HISTORIC PRESERVATION COMMISSION

AUGUST 27, 2020

To: Historic Preservation Commission
From: Peter Hughes, Senior Planner
CC: Darryn Burich, Planning and Inspections Director
Kelly Brown, Administrative Specialist
Date: August 20, 2020
Subject: Major COA Request for 55 Shaw Road (COA-2020-00098)

To: Historic Preservation Commission
From: Peter Hughes, Senior Planner
CC: Darryn Burich, Planning and Inspections Director
Kelly Brown, Administrative Specialist
Date: August 20, 2020
Subject: Major COA Request for 41 Shaw Road (COA-2020-00099)

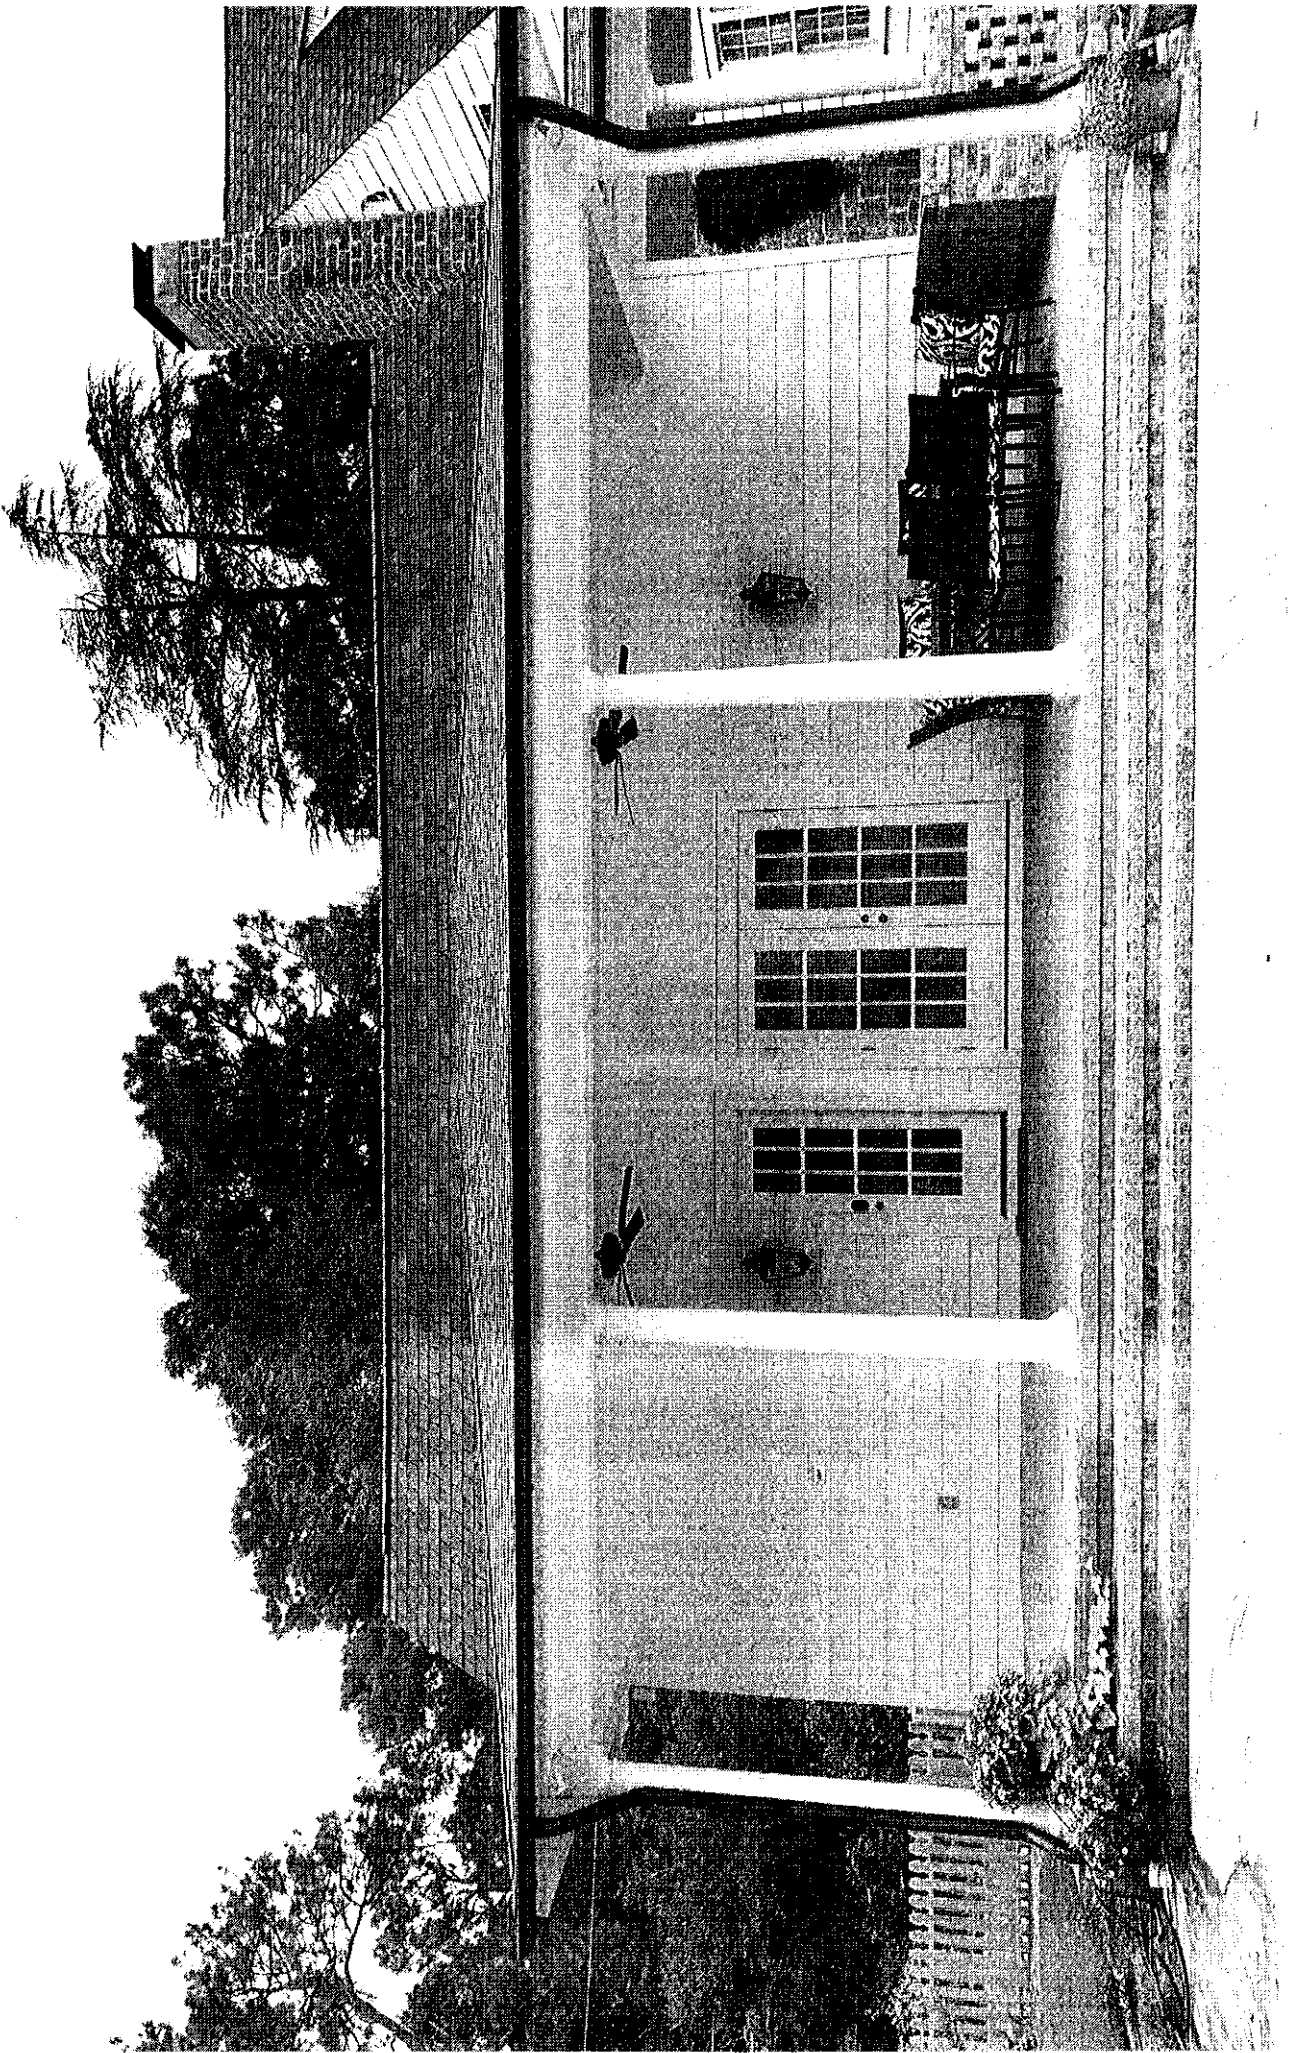
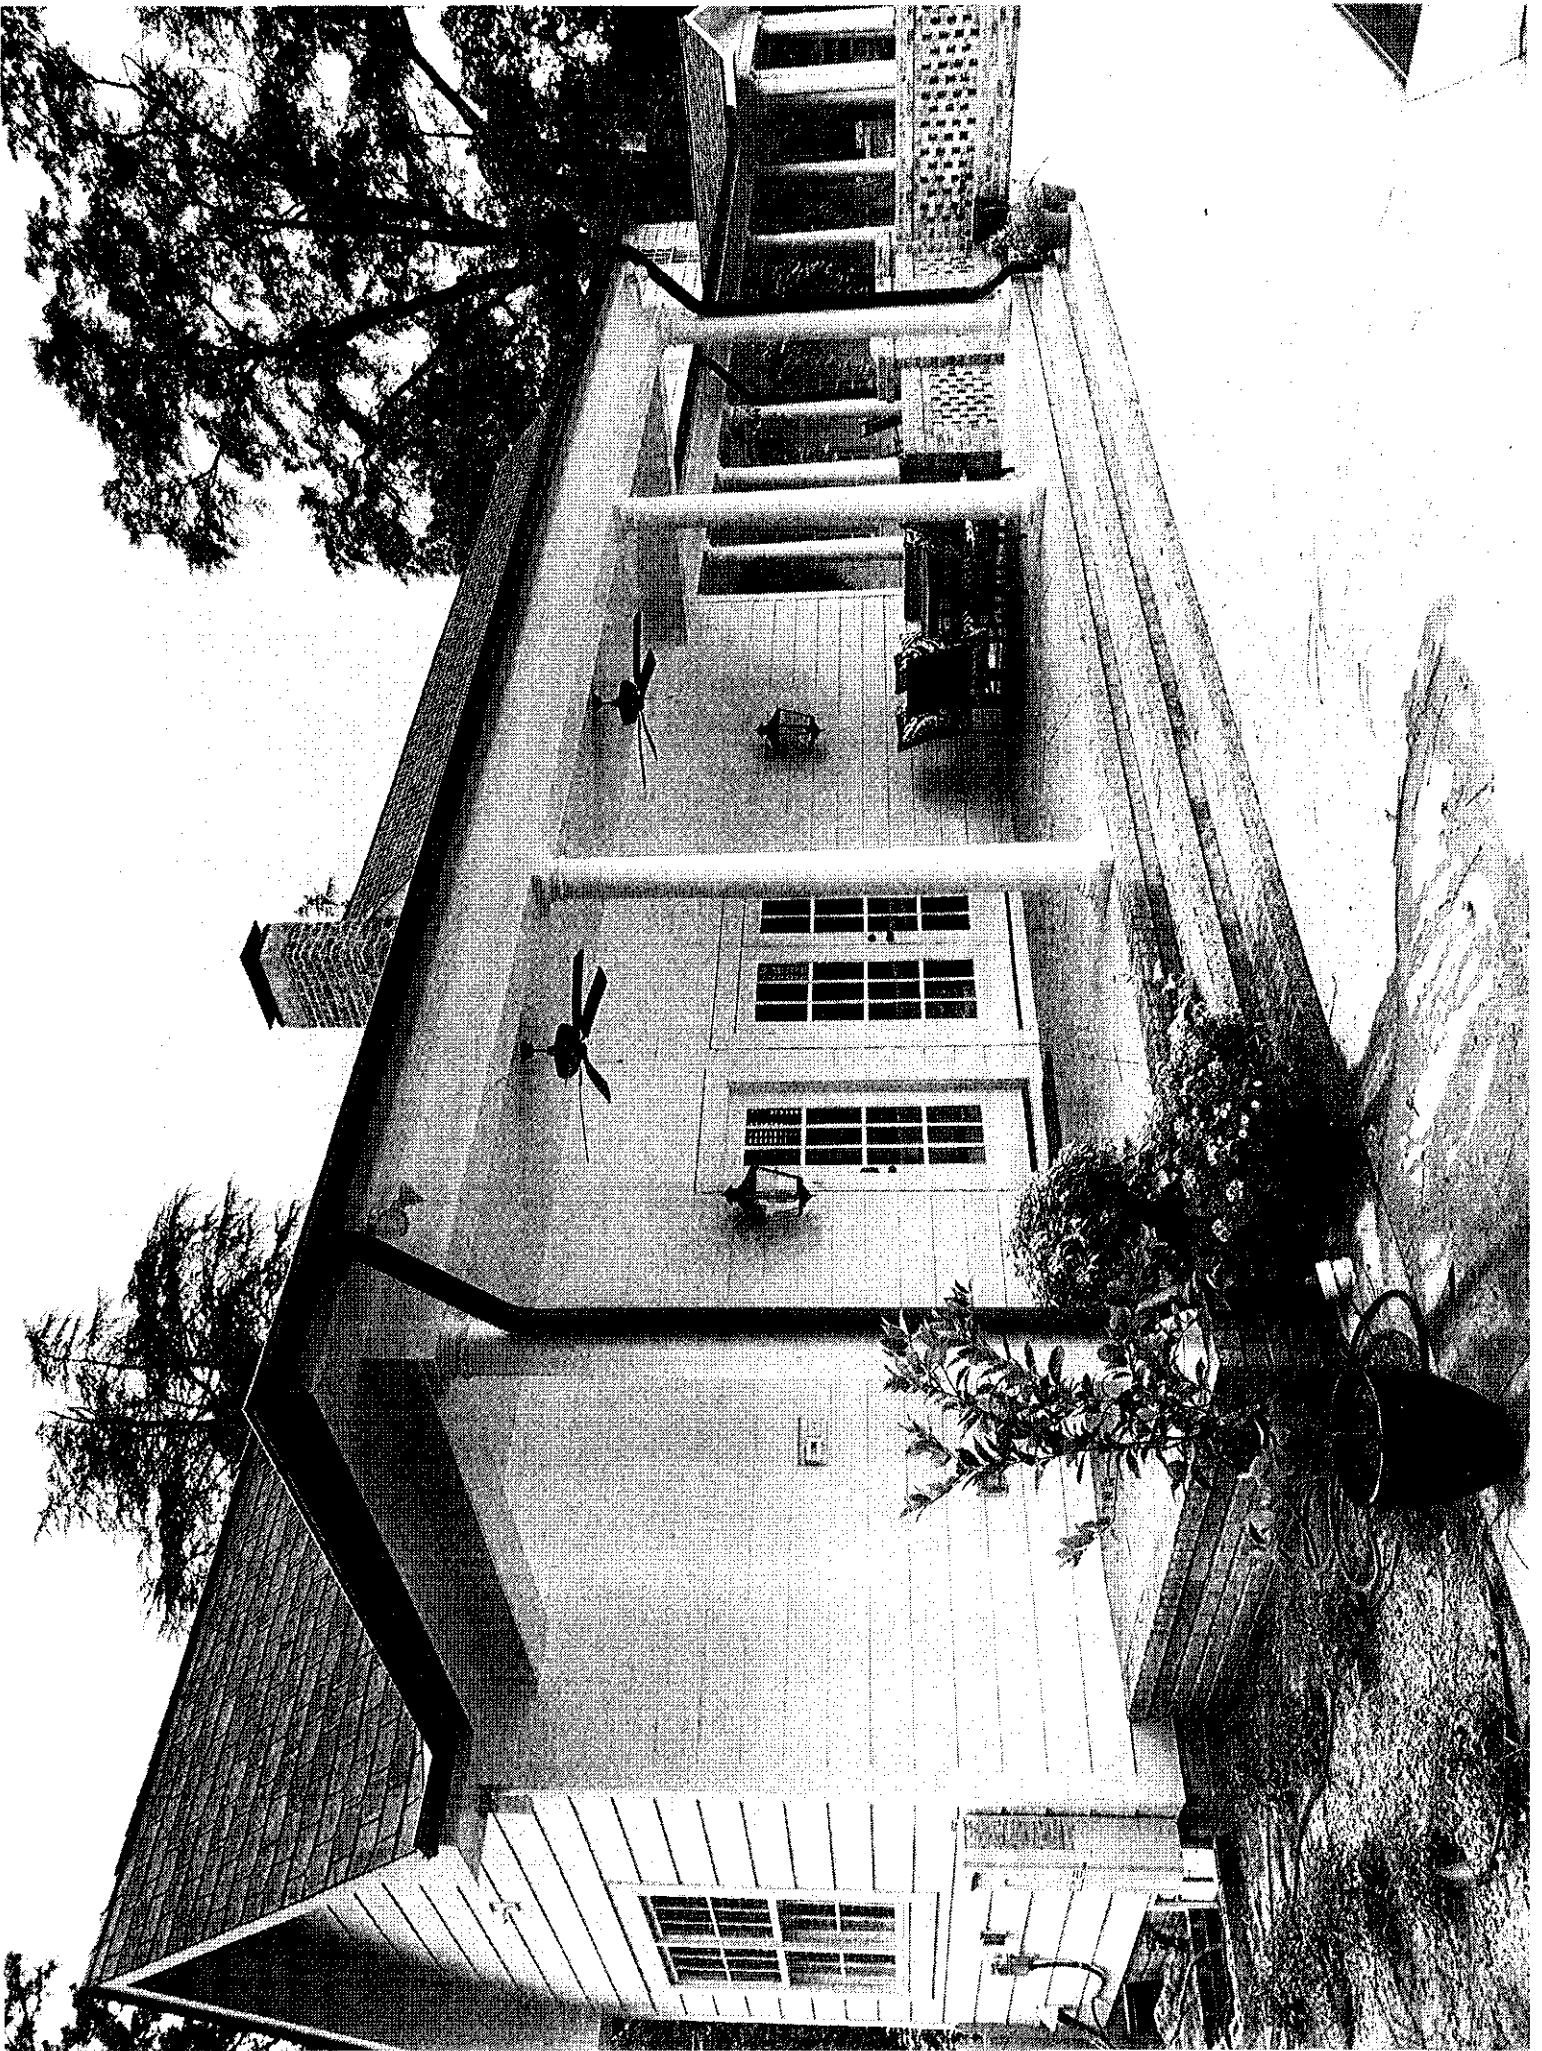
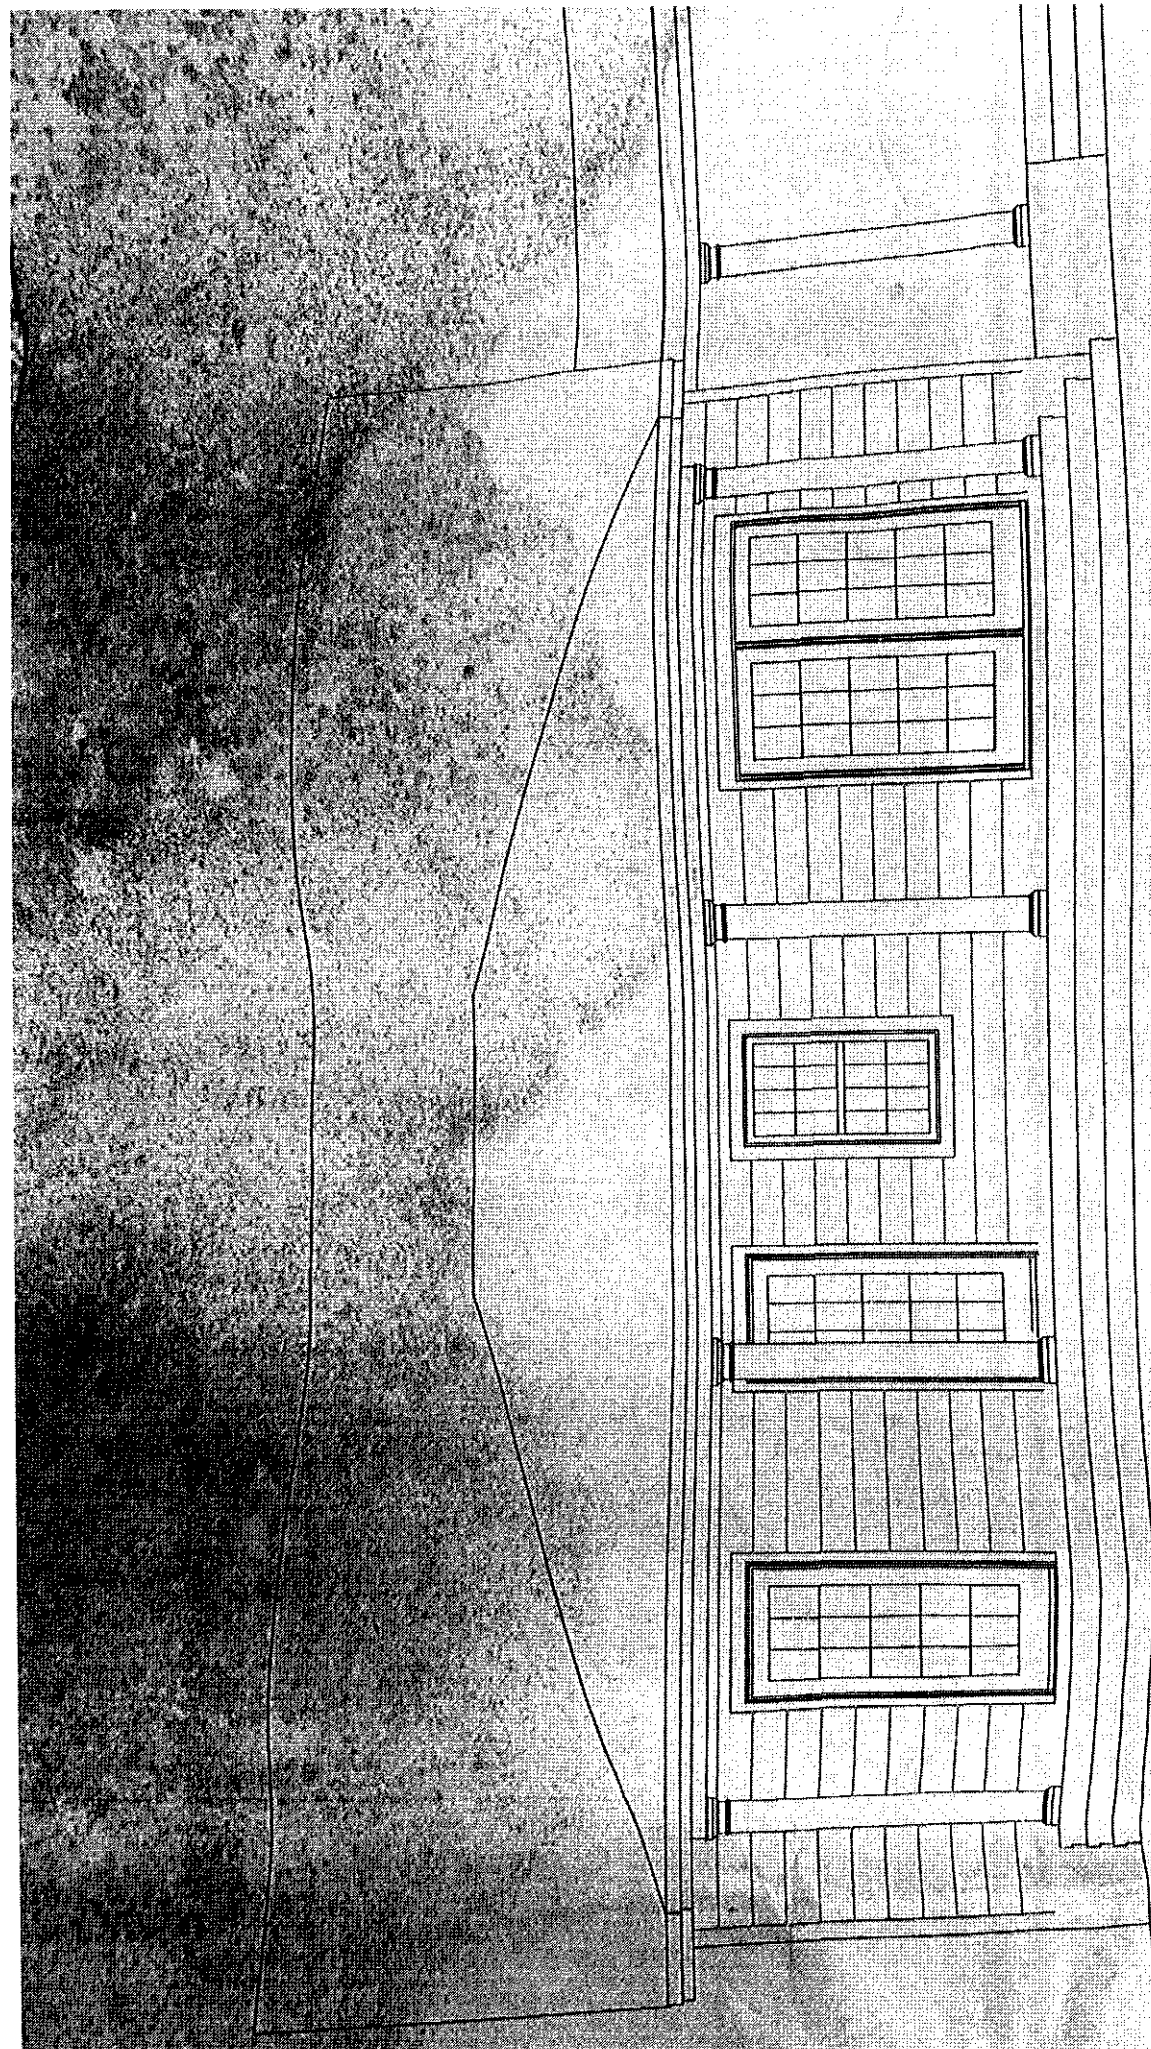
The 2020 design for the guest cottage appears to be more architecturally compatible with the primary residence because the primary residence elevation show even spacing between openings and none of the porch columns obscure any of the fenestration. In addition to being more architecturally compatible, the 2020 design would also appear to still be congruous with other guest cottages and pool houses within the Historic District.

The April 2019 approved plans illustrated one window and four glass doors on the rear façade of the guest cottage. The 2020 photo of the guest cottage shows no windows and three glass doors on the rear façade. The fenestration was reduced by one window and one door and the arrangement of the door layout was alter from what was approved. The change in number of openings does not compromise the architectural character of the structure. The changes occurred on the rear elevation and because of the topography and landscaping of the lot, these changes are difficult to see from the street. The front façade (streetscape) maintained a high volume of fenestration and the structure remains congruous with other accessory dwellings within the Historic District.

Staff believes this request is in conformity with the Guidelines and recommends approval of this modification to a previously approved COA.
